ADDENDUM NUMBER 2

NOTIFICATION DATE:	SOLICITATION TITLE:	SOLICITATION NUMBER:	BID OPENING DATE & TIME:
2/7/2022	Median Restoration on Goodlette Frank Road - 7th Ave N to Golden Gate Pkwy - Phase 2 - ITB	22-011	2/11/2022 2:00PM

LANDSCAPE TABULATION OF QUANTITIES AND PLANT SCHEDULE

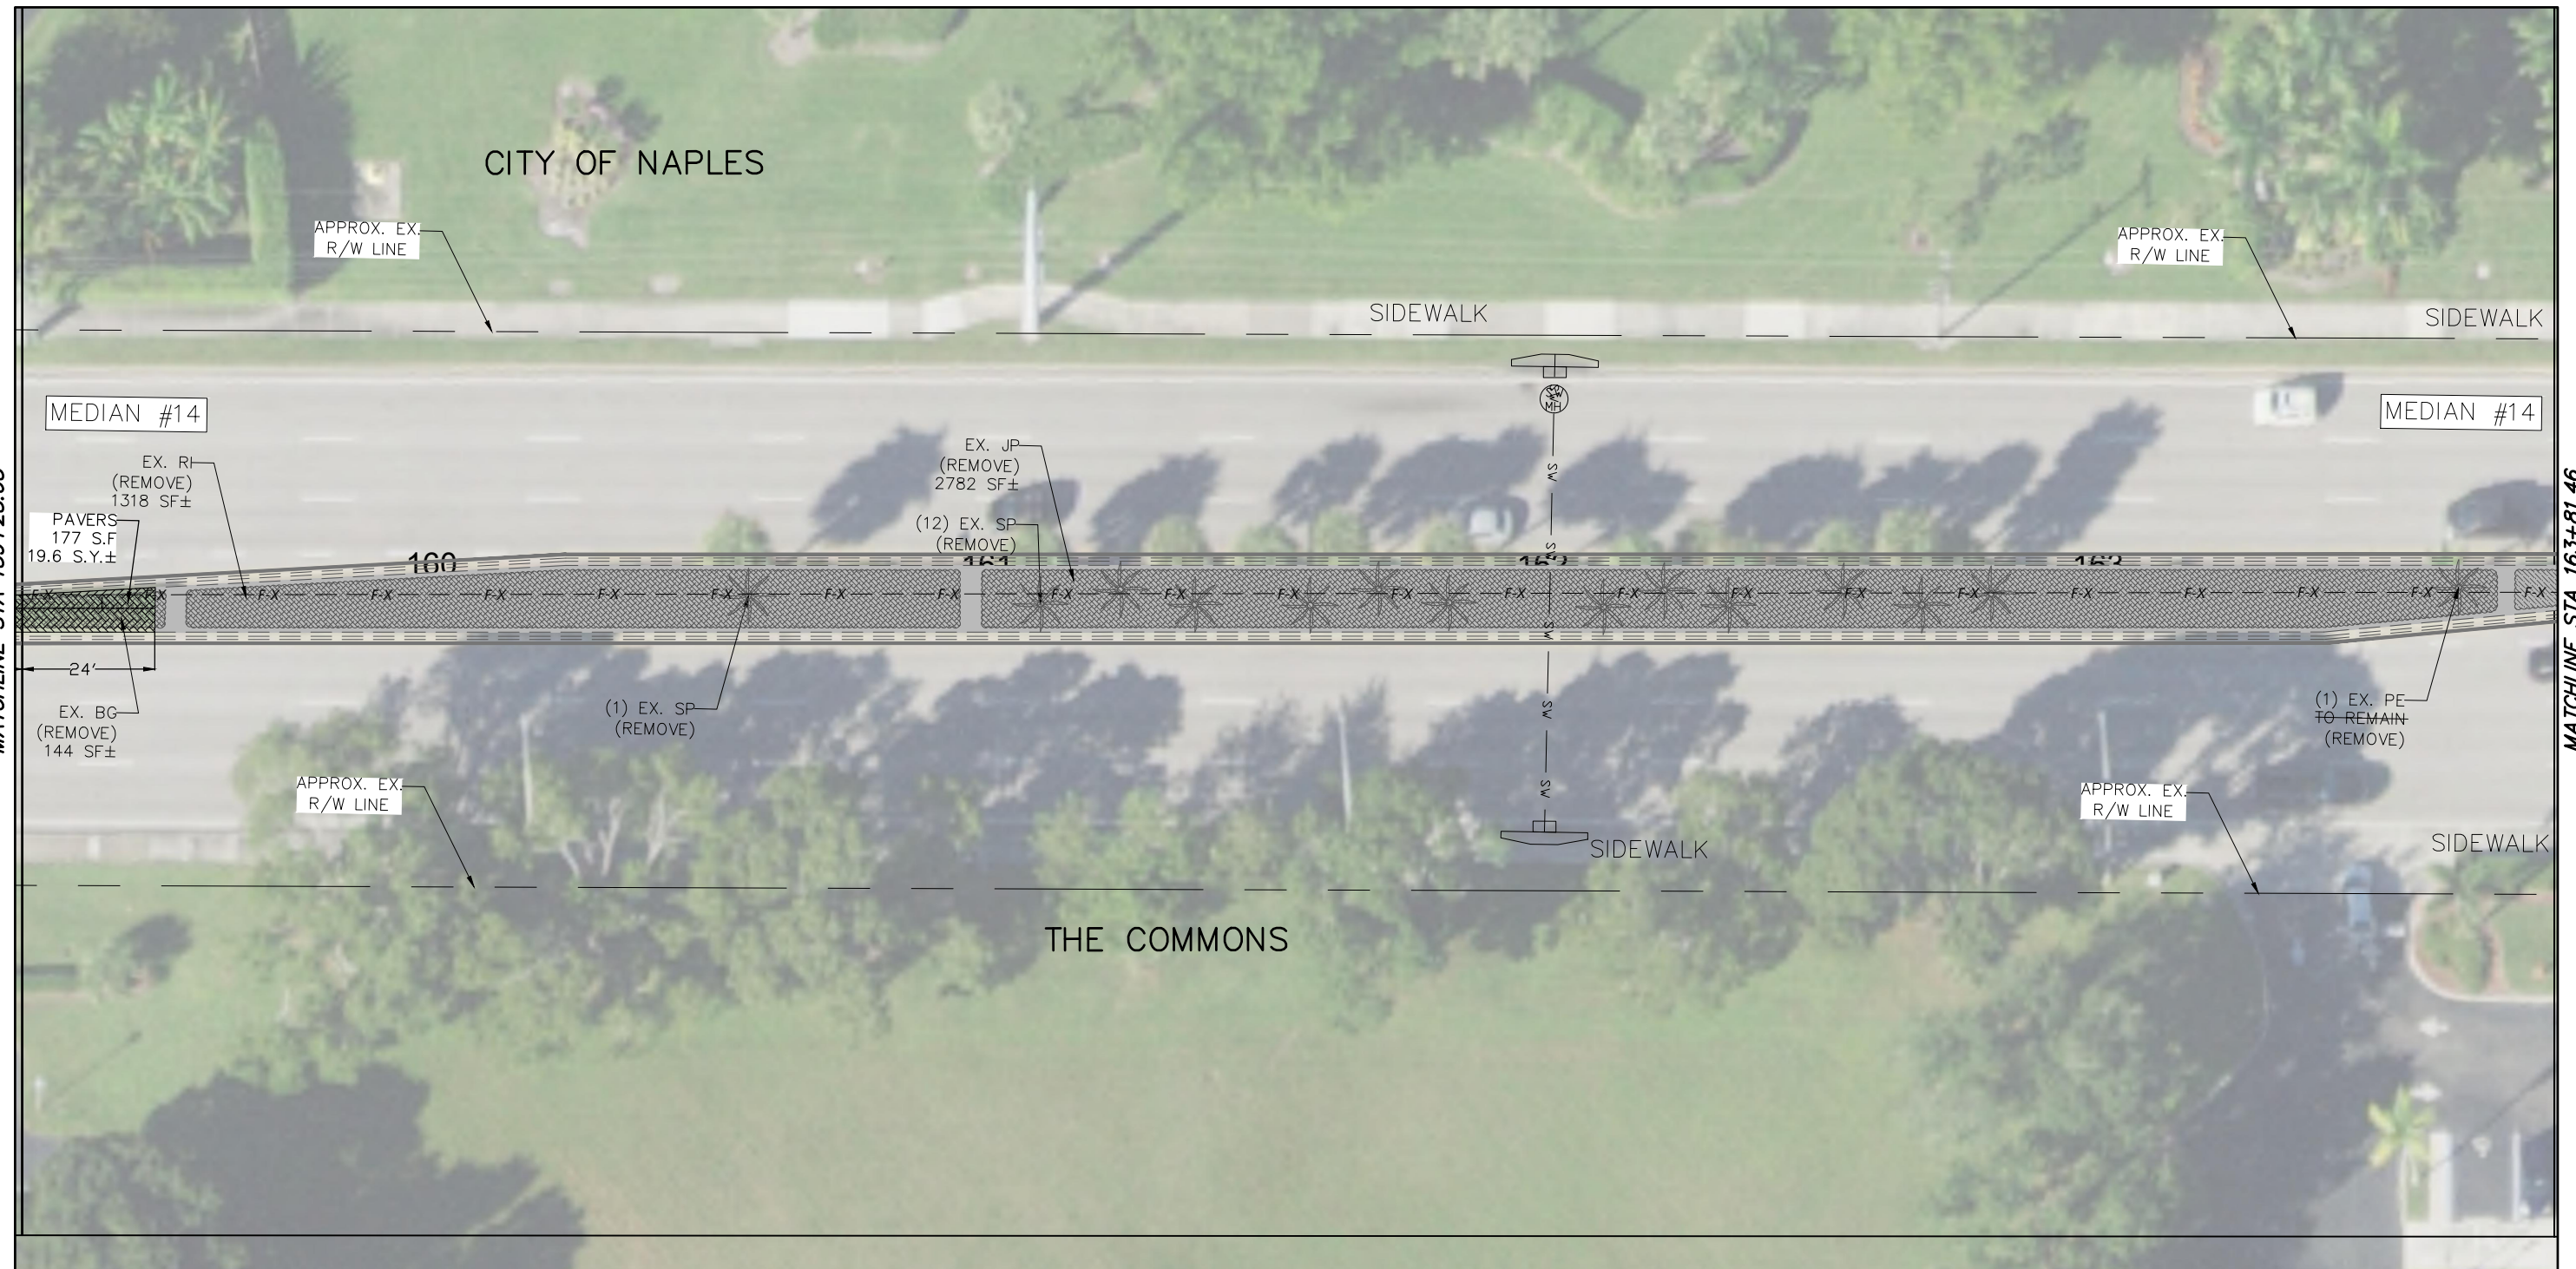
4. Please confirm the quantities of (HP, WA, CB, CG) on sheet LD-22 as they apparently do not match the plans?

ANSWER: Sheet LD-22 revised to correct quantities.

DATE	BY	DESCRIPTION	DATE	BY	DESCRIPTION	<p>McGee & Associates Landscape Architecture DESIGN * ENVIRONMENTAL MANAGEMENT * PLANNING 5079 Tamiami Trail East * Naples, Florida 34113 Phone: (239) 417-0707 Fax: (239) 417-0708 Certificate of Authorization LC-C000098</p>	<p>CITY OF NAPLES CITY COUNCIL COMMUNITY SERVICES DEPARTMENT</p>			<p>LANDSCAPE PLAN PLANTING PLAN TABULATION OF QUANTITIES</p>		<p>SHEET NO. LD-22</p>
1/31/22	MAM	REVISED PLANT QUANTITIES					ROAD NO.	COUNTY	PROJECT ID			
							CR851	COLLIER	20-02-09-13-20F32-PH2

SHEET NO.
LD-45

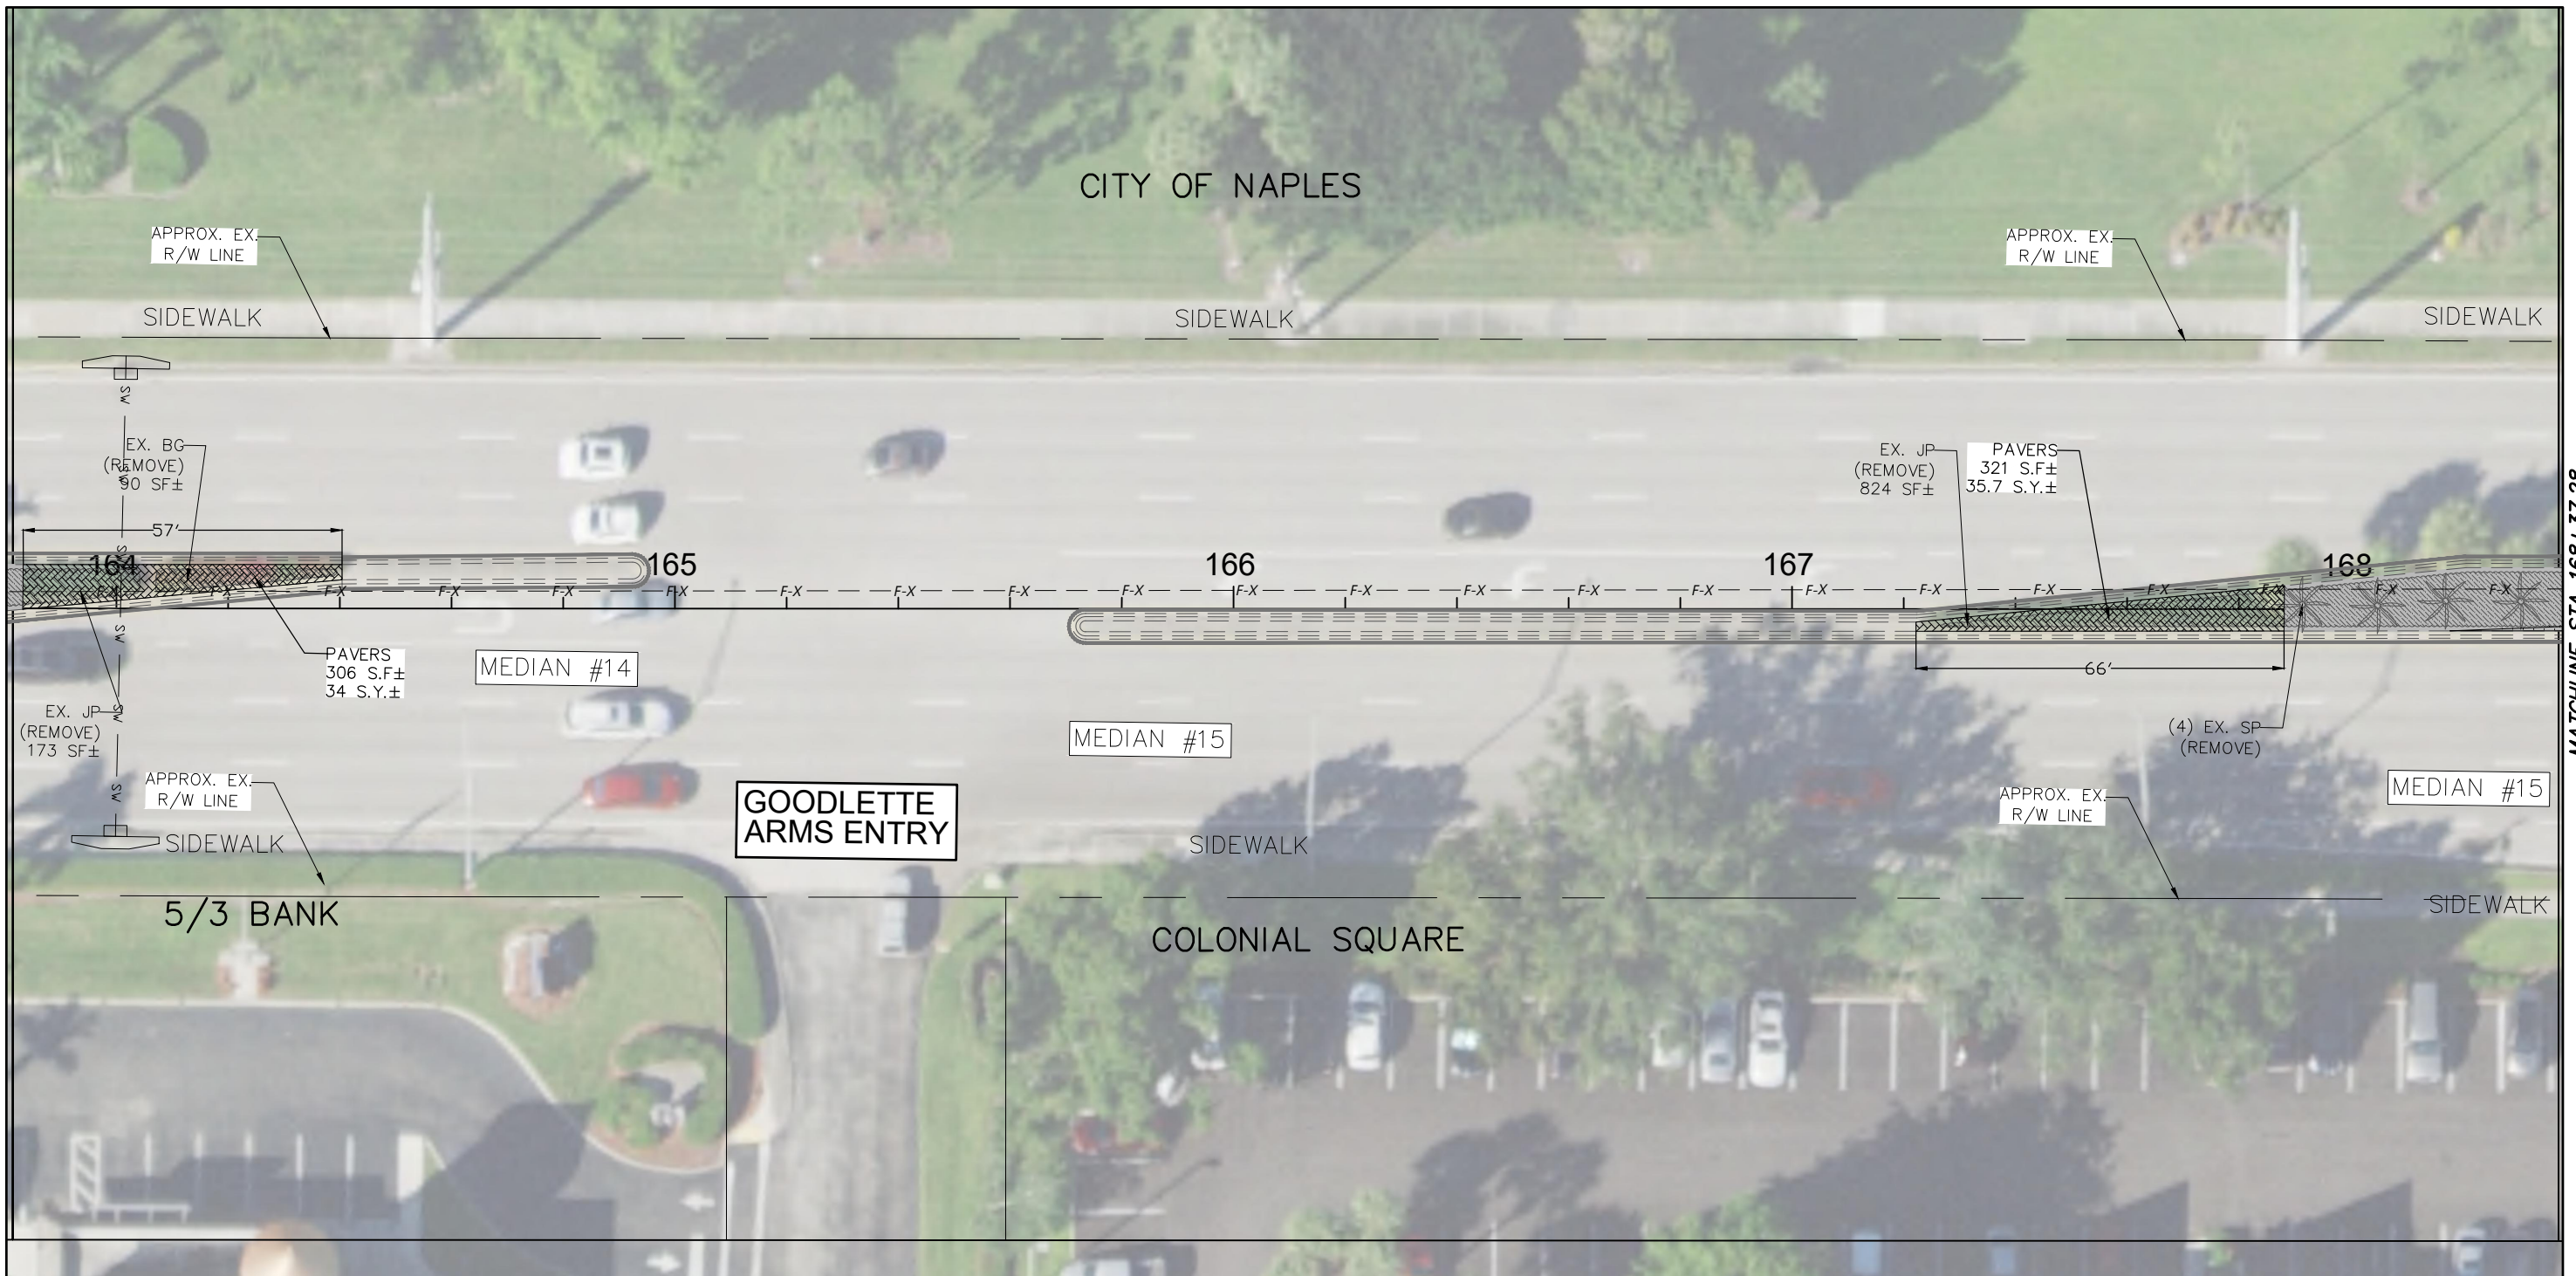
1. The plans show us leaving ex. various trees in the medians. In the pre-bid meeting, it was noted that all trees and palms are to be removed except (3) Oak trees. In addition, all the shrubs are to be removed except in medians near Fleischmann Blvd. Please confirm the trees and planting to remove?

ANSWER: Only four Oak trees in median #22 are to remain; see revised demo #1.

DATE	BY	DESCRIPTION	DATE	BY	DESCRIPTION
1/31/22	MAM	REVISED TREE REMOVAL LABELS
